**PARK 410 WEST PRELIMINARY
OVERALL AREA DEVELOPMENT PLAN**
OWNER: PARK 410 WEST JOINT VENTURE
ADDRESS: 405 N. ST. MARY'S, SUITE 222
SAN ANTONIO, TEXAS 78205

Re: Park 410 West (Amendment)

POADP # 107-A

Re: Administrative Revision of Park 410 West P.O.A.D.P.

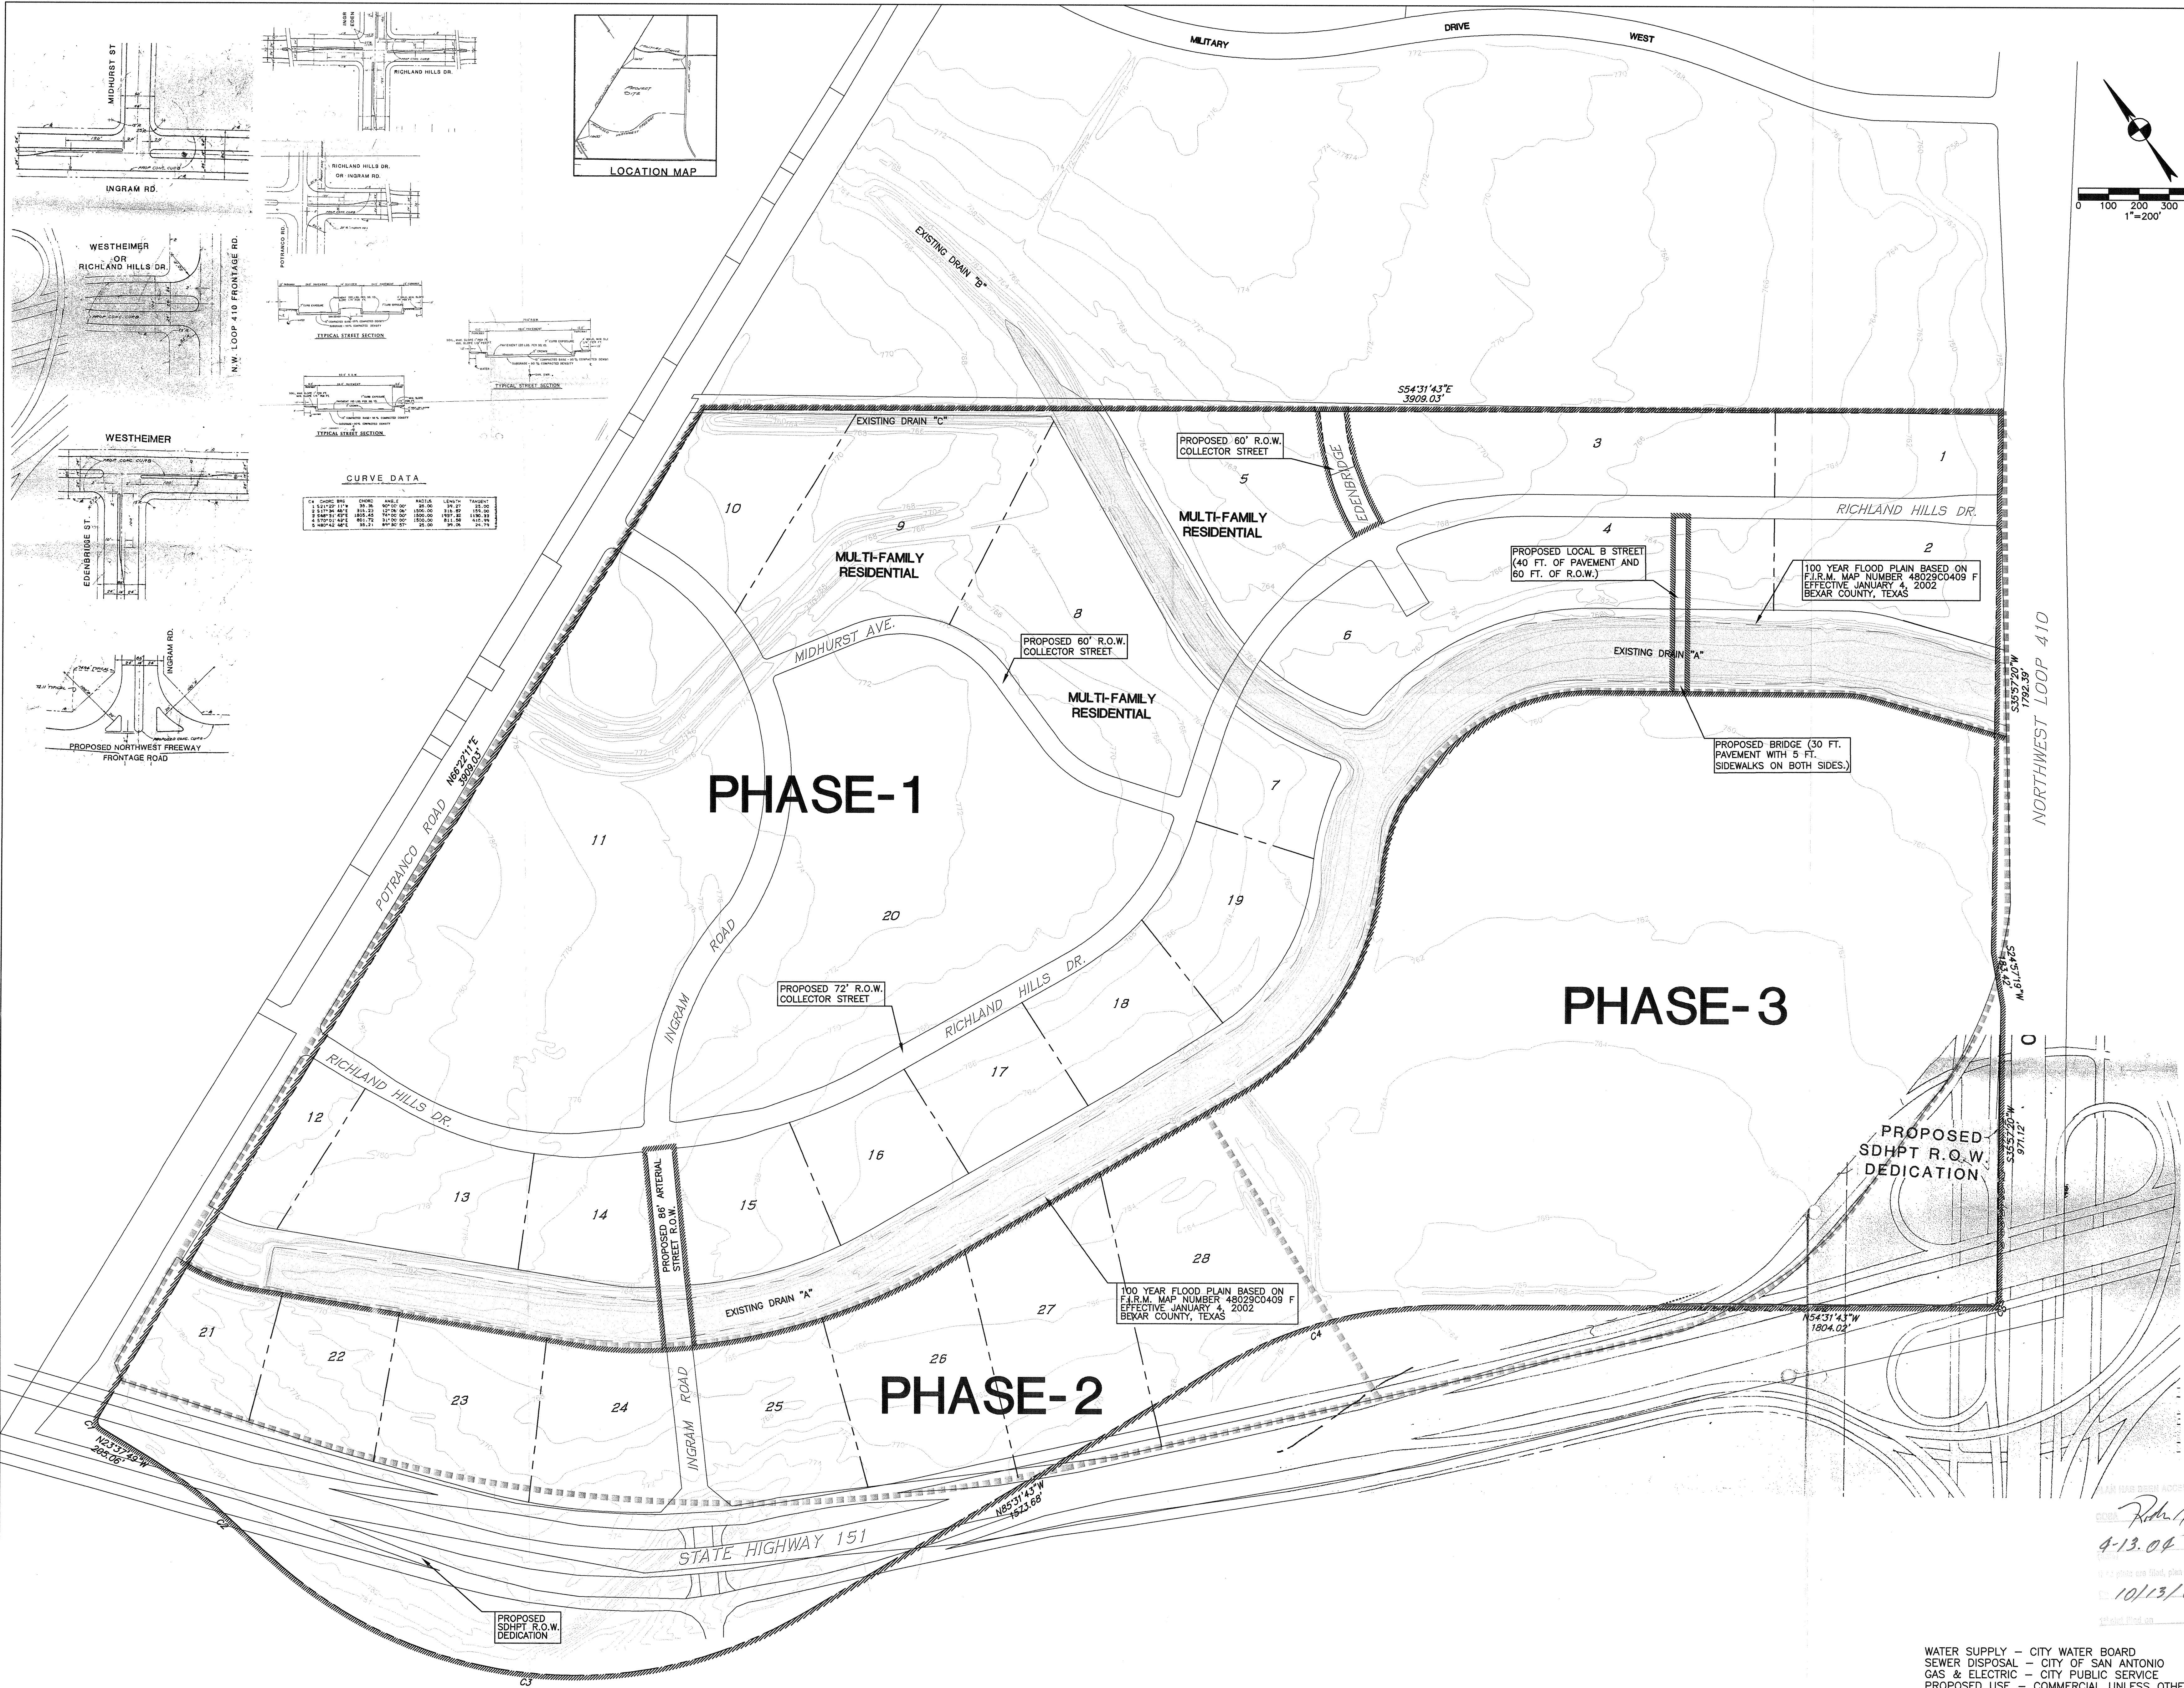
The City Staff Development Review Committee has reviewed Park 410 West (Amendment) Preliminary Overall Area Development Plan (POADP) # 107-A. Please find enclosed a signed copy for your files. Your plan was accepted, however please note the following:

- In consideration of public safety and convenience, excessive grades by reason of topography should be avoided in street layouts and arrangements.
- Potranco Road is on the Major Thoroughfare plan as a Primary Arterial requiring 120' of Right-of-Way. Dedication along said thoroughfare will be required upon platting.
- Any access and R.O.W. issues along state facilities will need to be resolved with the Texas Department of Transportation (TXDOT). For information about these requirements you can contact TXDOT at 615-5814.
- It will be expected that you will plat all of the property depicted in your POADP to include floodplains, drainage areas and open space.
- I would encourage you to work closely with the school district, so that they can plan accordingly.

**PARK 410 WEST PRELIMINARY
OVERALL AREA DEVELOPMENT PLAN**
OWNER: PARK 410 WEST JOINT VENTURE
ADDRESS: 405 N. ST. MARYS, SUITE 222
SAN ANTONIO, TEXAS 78205

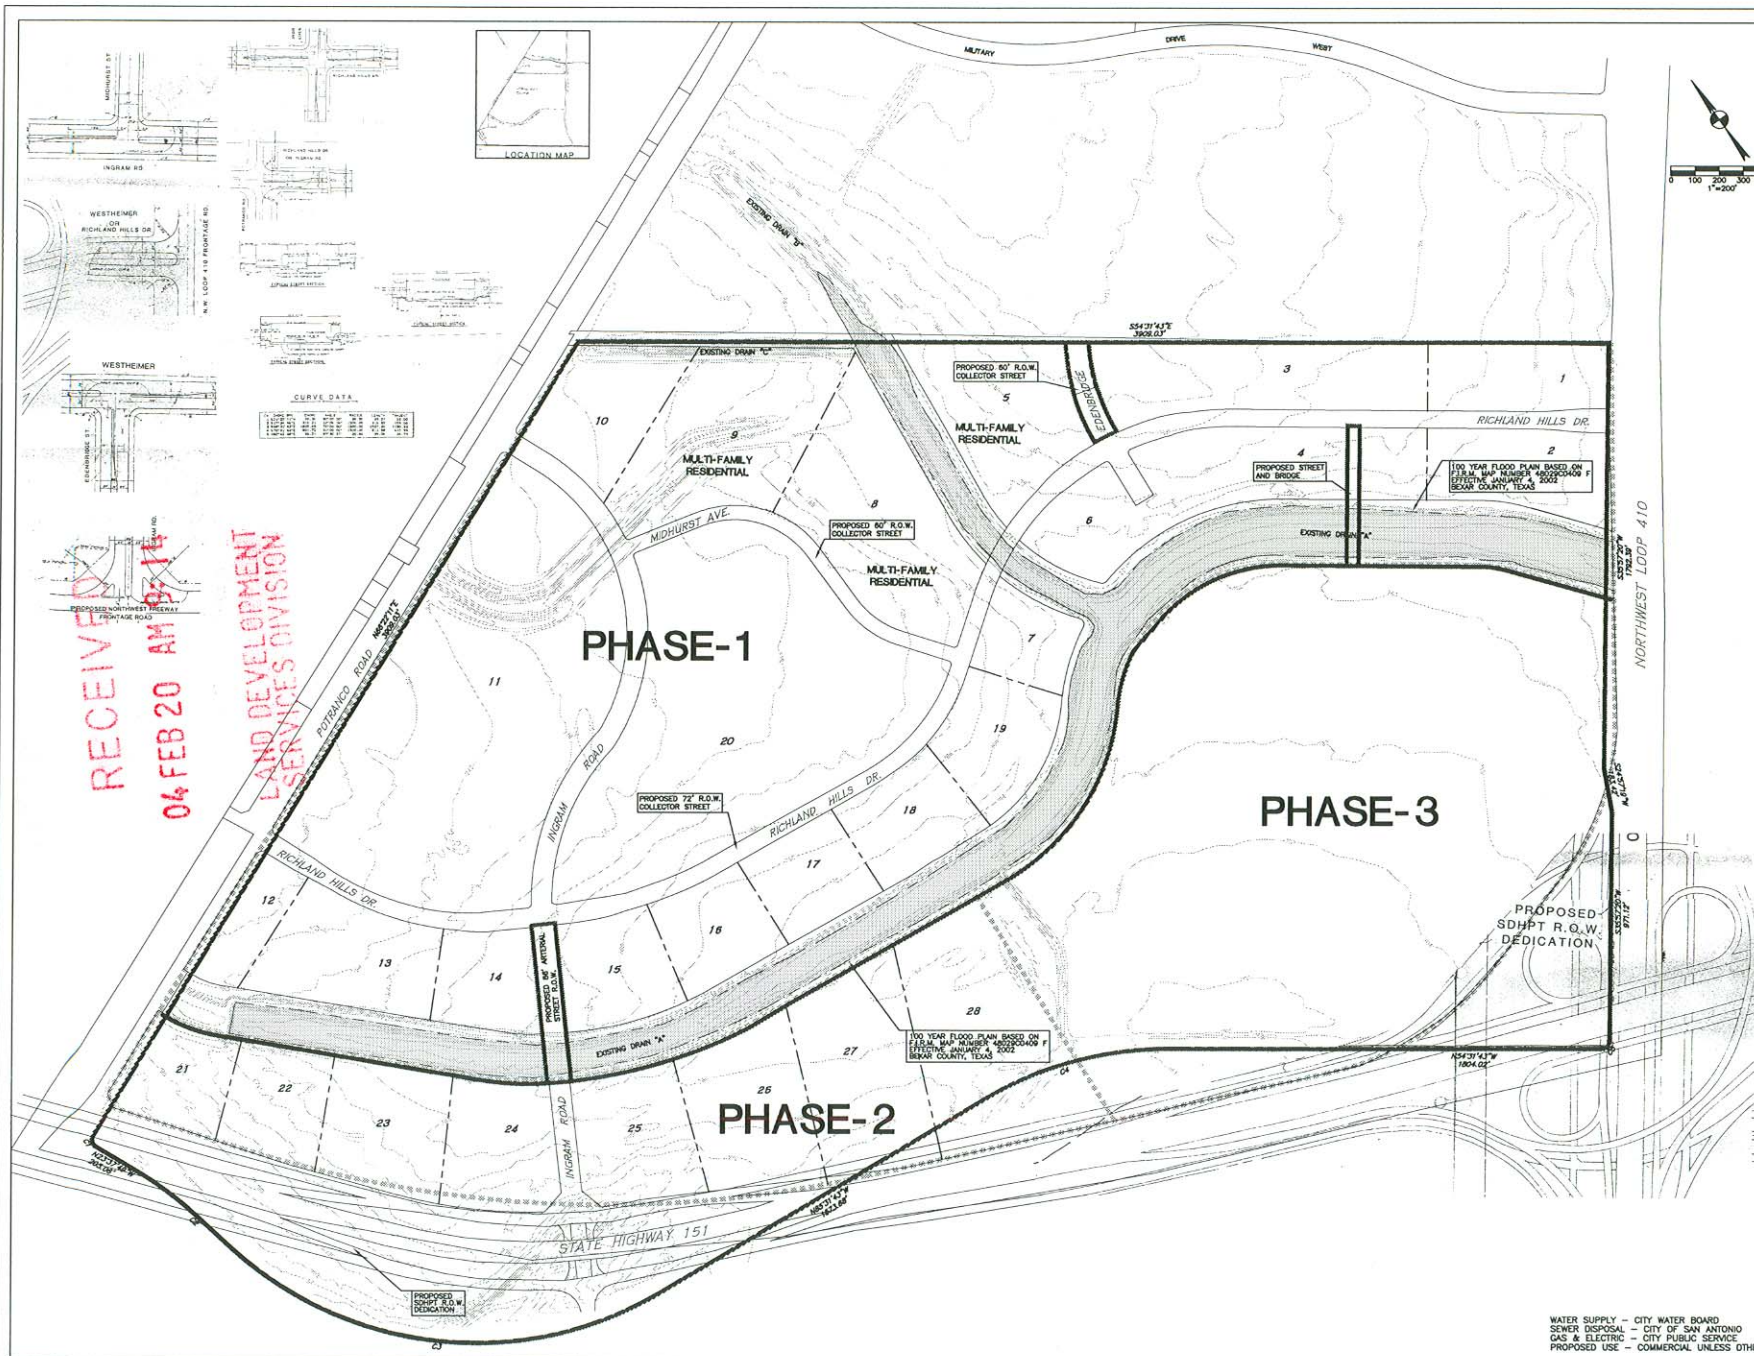
This submittal is to revise the above referenced P.O.A.D.P. The revisions are contained within Phases 1 and 3 only. We propose to eliminate Westheimer (86-ft Collector Street) and move the part of Edenbridge south of Richland Hills Dr. more to the east (see enclosed revised P.O.A.D.P.). The reason for our revisions is based upon existing conditions. A Lowe's home improvement store was constructed where part of Westheimer was to be located. As a result, the subject loop road has become infeasible.

This P.O.A.D.P. revision also proposes to relocate the portion of Edenbridge, which crosses Slick Ranch Creek more to the east closer to Loop 410. This is due to the configuration of the Westover Market Place Subdivision's site plan (see attached preliminary site plan). Also note that the floodplain has been updated to reflect the current FEMA map (see attached) for this portion of Slick Ranch Creek.
